2020 Corvette: Service Bulletin:: #20-NA-179: Malfunction Indicator Lamp (MIL) Illuminated - DTCs P0521 and/or P06DD Set - (Oct 23, 2020)

Subject: Malfunction Indicator Lamp (MIL) Illuminated – DTCs P0521 and/or P06DD Set

Brand:	Model:	Model Year:		VIN Breakpoint:		Engine:	Transmission:
		from	to	from	to		
Chevrolet	Corvette	2020	2020	SORP	September 10, 2020	6.2L (LT2)	—

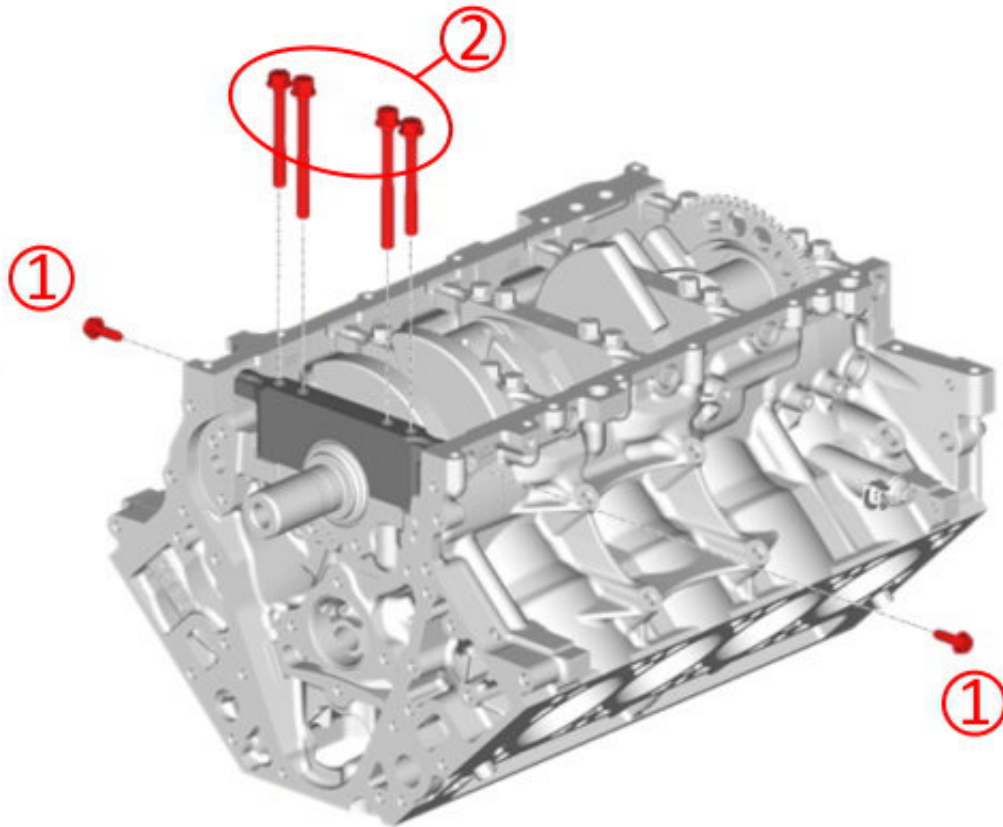
If P0521 and P06DD DTCs are present, then a redesigned oil pressure control valve retainer clip (1) may be necessary. Refer to the Service Procedure section below.

1. Remove the engine oil pan. Refer to *Oil Pan Replacement* in SI.

Note: The generator may need to be repositioned to gain access to the main cap side bolts.

1. Remove the main cap side bolts (1).

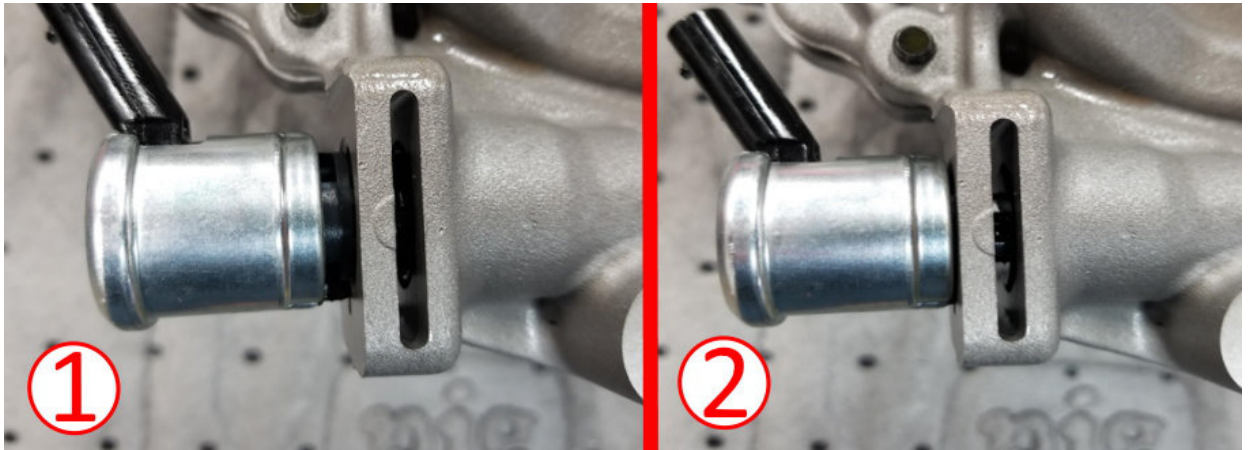
Important: When removing the main bearing cap be careful not to damage the main bearing or journal surface of the crankshaft. Please set the main bearing cap in a safe place so no debris or damage could occur.

1. Remove and discard the bolts (2) that secure the #1 main bearing cap.

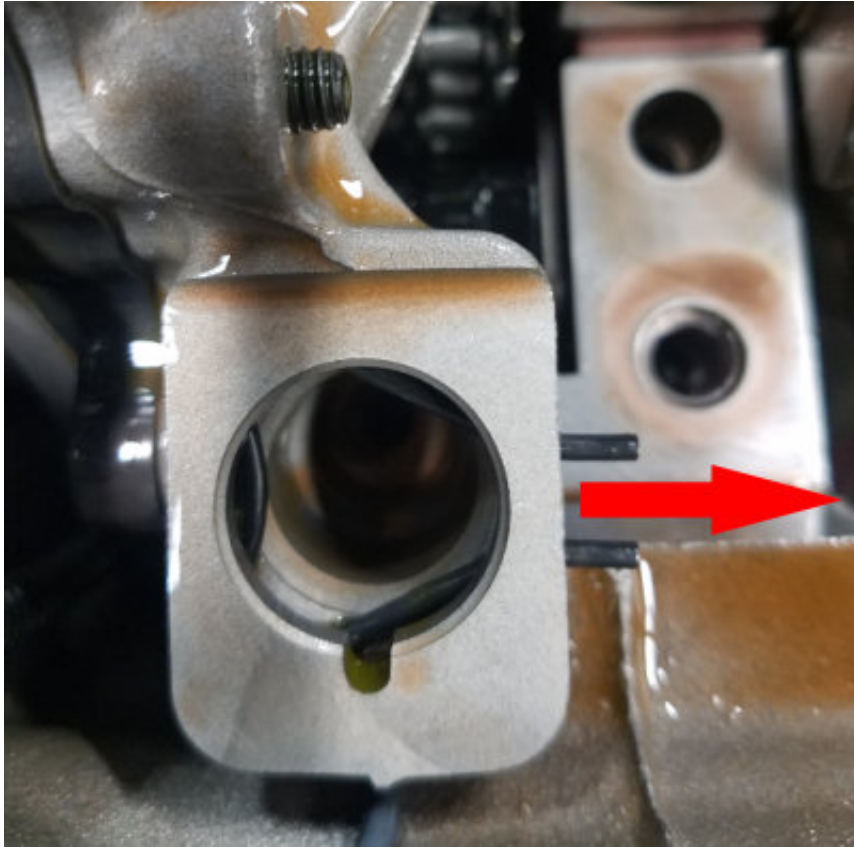
1. Inspect the OCV:
 - If you find this oil pressure control valve dislodged (1), it will be necessary to install a redesigned oil control valve retainer.
- Disconnect the oil pressure control valve electrical connector and position aside.

Note: Remove the existing oil pressure control valve retainer by pulling towards the rear and discard. You will be installing a newly designed retainer during installation.

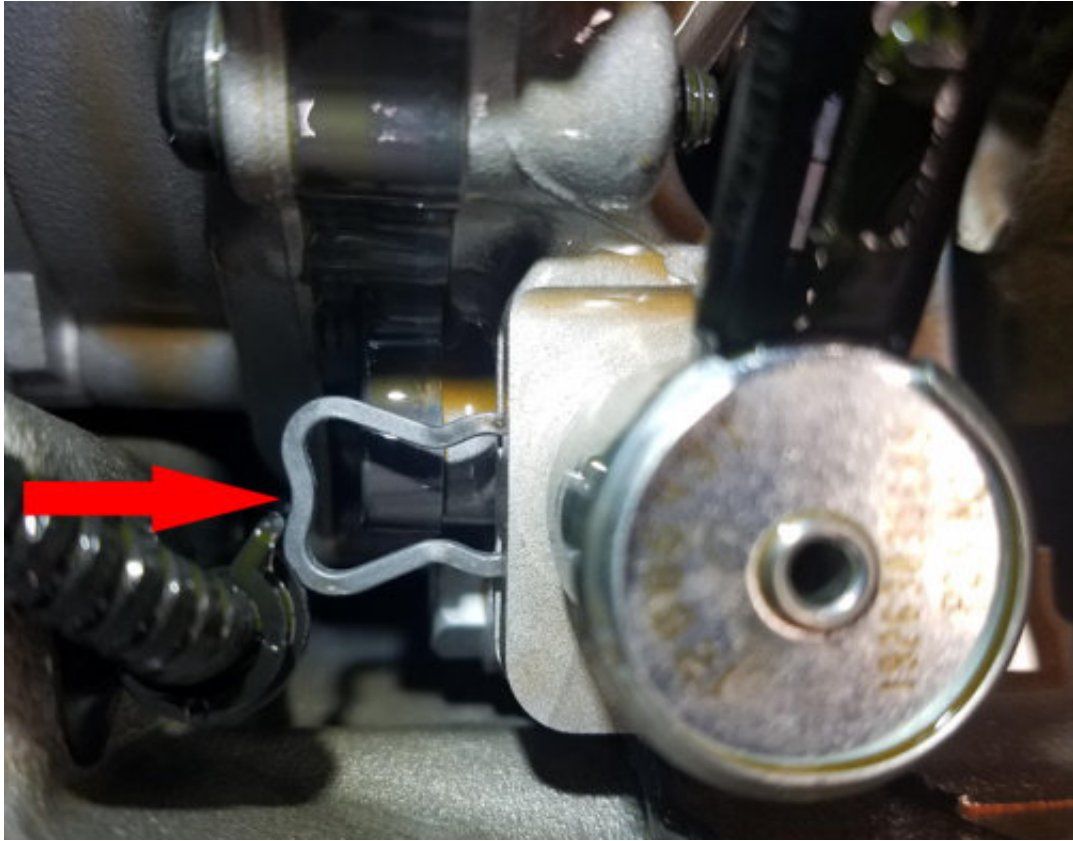
1. Push in the retainer and remove the oil pressure control valve and set aside.
 2. Once the retainer is removed, inspect the oil pressure control valve for any signs of damage and ensure the O-ring is not cut.
- Apply a small amount of clean engine oil to the pressure control valve and reinstall ensuring it is seated correctly.

Important: Do not use any tools to tap the pressure control valve into place. Only install the pressure control valve by pushing on the body of the valve by hand.

1. Install the new retainer from the front of engine towards the rear as shown in the graphic above.

1. When the retainer is installed, there should be about 2 to 3 mm of clearance between the retainer and the oil pump body as shown above.
 - Ensure the pressure control valve and retainer are correctly installed.
- Ensure the cap and bearing are VERY CLEAN and apply assembly lube prior to installation.
- Install the front main bearing cap with new bolts.
